MOTORCYCLE SERVICE NEWS

NUMBER 300

DATE 10/13/72

TX750 HEADSTOCK GUSSET, Enlargement of wiring hole

Right Side

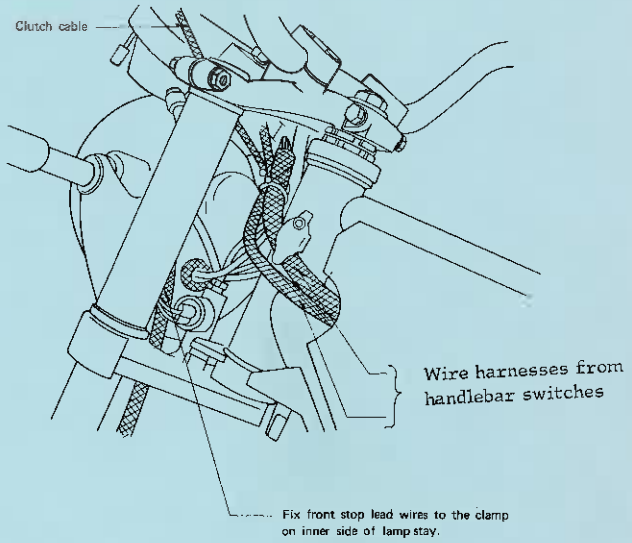
On some TX750 machines, the wiring hole on the right-hand headstock gusset is not large enough to pass the main switch harness connector. This hole may be enlarged by inserting the chisel end of a 24" (+) crowbar between the gusset and head pipe, and carefully and slowly bending out the gusset.

Be careful when using the crowbar that wiring inside frame near headstock is not damaged. See drawings below for correct routing of electrical wiring and control cables in headstock area.
